## UFTR Safety Analysis Report Revision 8, 5/95

Re: University of Florida Training Reactor (UFTR)  
Facility License: R-56; Docket No. 50-83

The enclosed package contains Revision 8 pages for the UFTR Safety Analysis Report dated January, 1981 submitted as part of our relicensing effort. Revision 8 consists of changes to two pages. The revision has resulted from the need to make certain minor changes in the schematics describing the UFTR Secondary Water Cooling System to reflect modifications that have been implemented. There were no textual changes required in the Safety Analysis Report. All changes have been reviewed by UFTR management and the UFTR Safety Review Subcommittee and are not considered to involve any unreviewed safety question or to impact the UFTR Safety Analysis as outlined below.

Figure 5-5. Schematic of UFTR Secondary Water Cooling System.

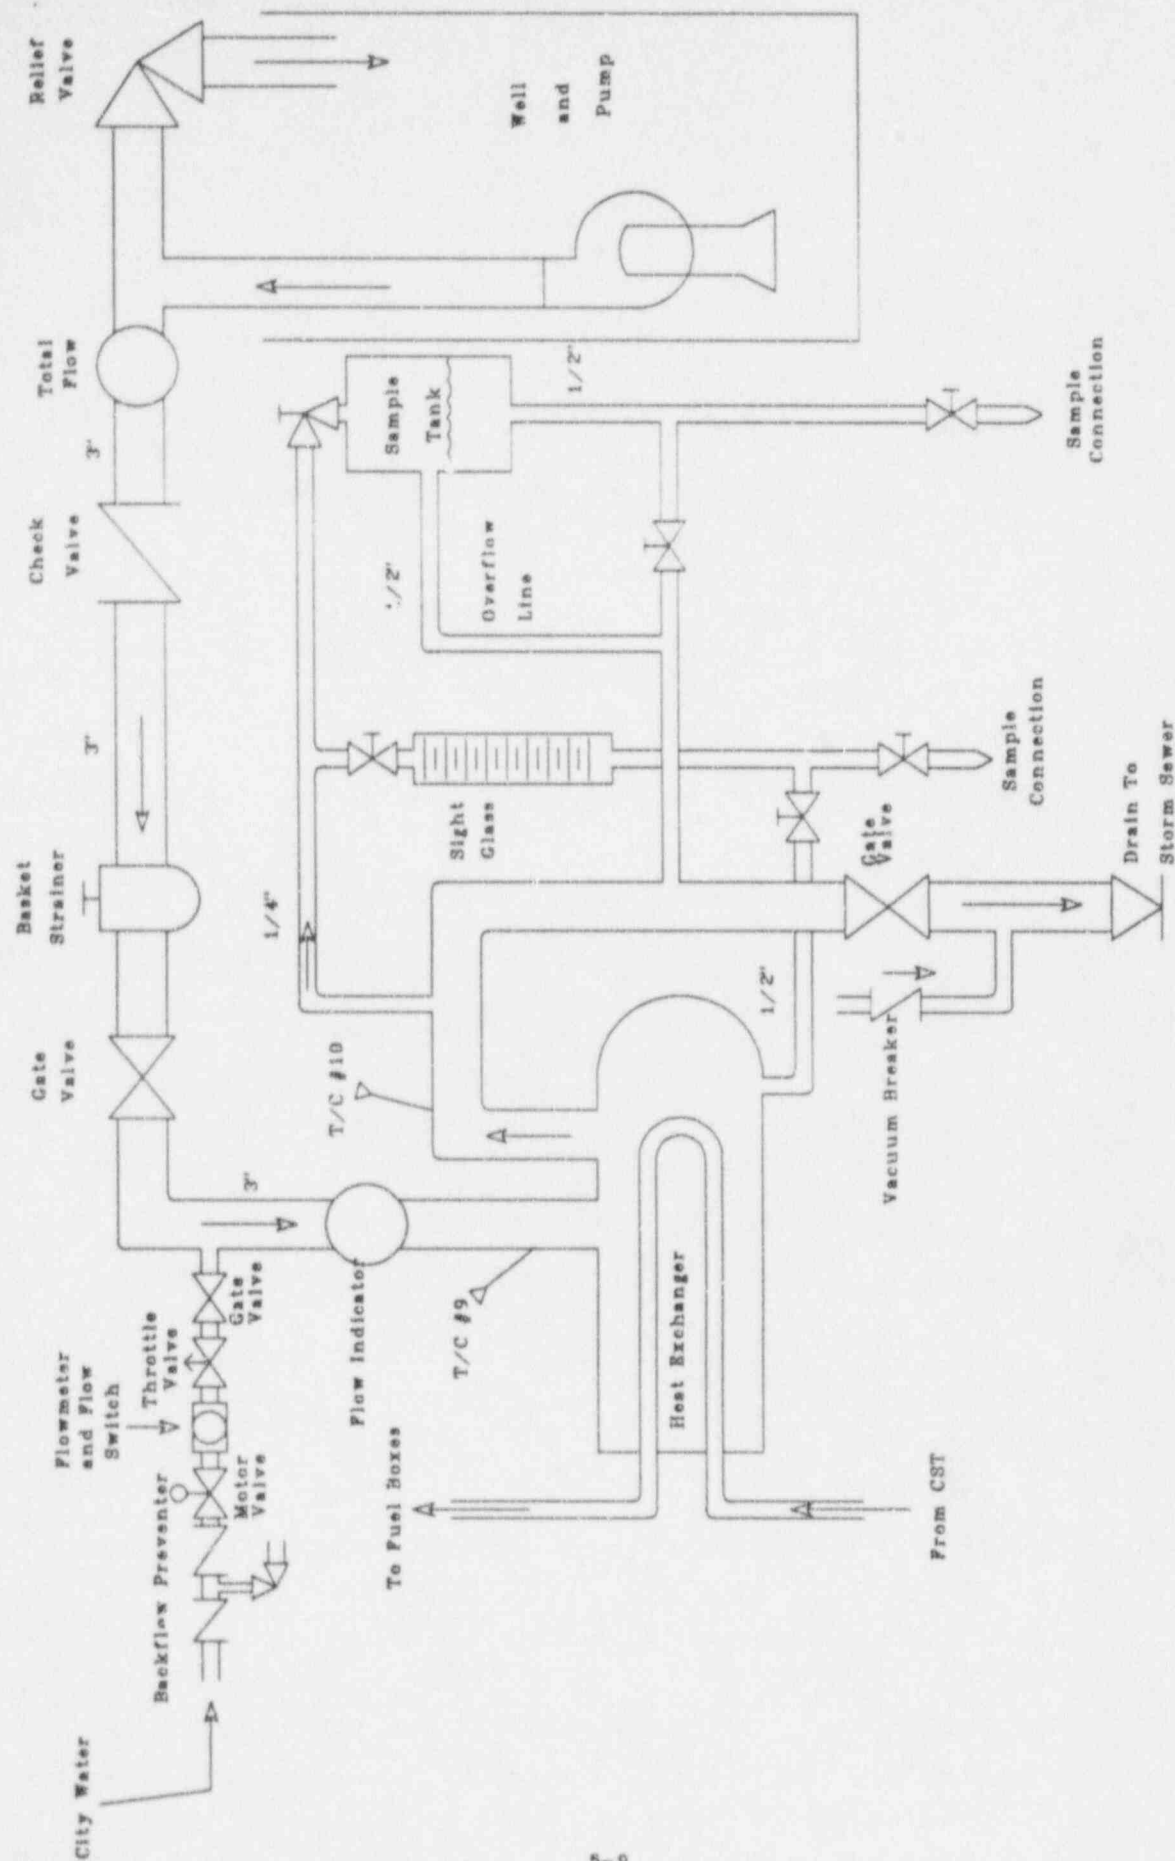
The first change is included on Page 5-9 in Figure 5-5 entitled "Schematic of UFTR Secondary Water Cooling System" to reflect installation of a flowmeter and flowswitch and removal of the previously installed slip union and pressure switch for the city water secondary cooling supply line. This change was evaluated and determined not to involve any unreviewed safety questions per 10 CFR 50.59 Number 93-09.

This installation of a flowmeter on the city water side of the secondary piping is to allow an accurate determination of flow in the city water cooling mode. The installation of the throttle valve is to allow for improved controllable throttling characteristics for the city water cooling mode. This installation was completed in November, 1993.

Figure 9-3. UPTR Secondary Water Cooling System.

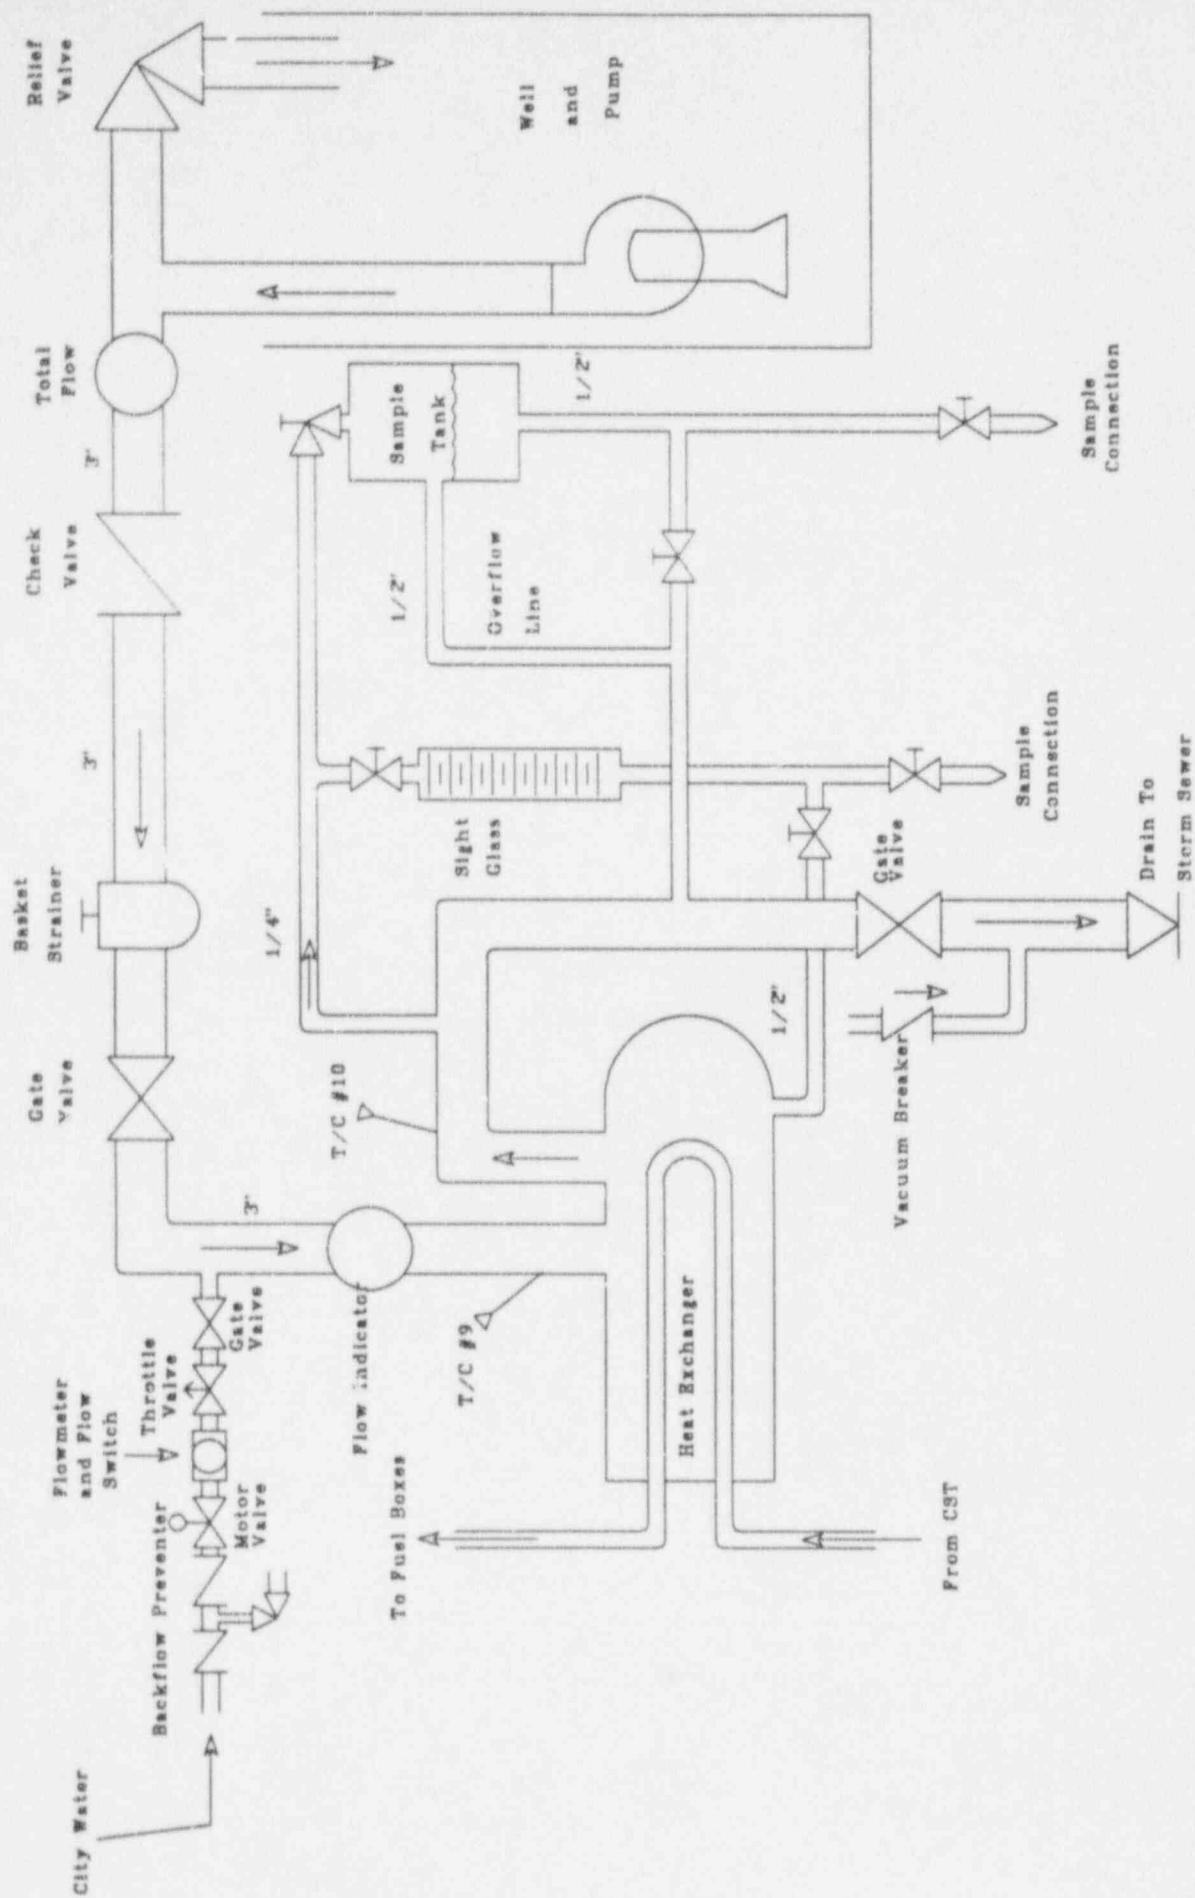
The second change is included on Page 9-7 in Figure 9-3 entitled "UFTR Secondary Water Cooling System." This change is the same as that described in the previous paragraph.
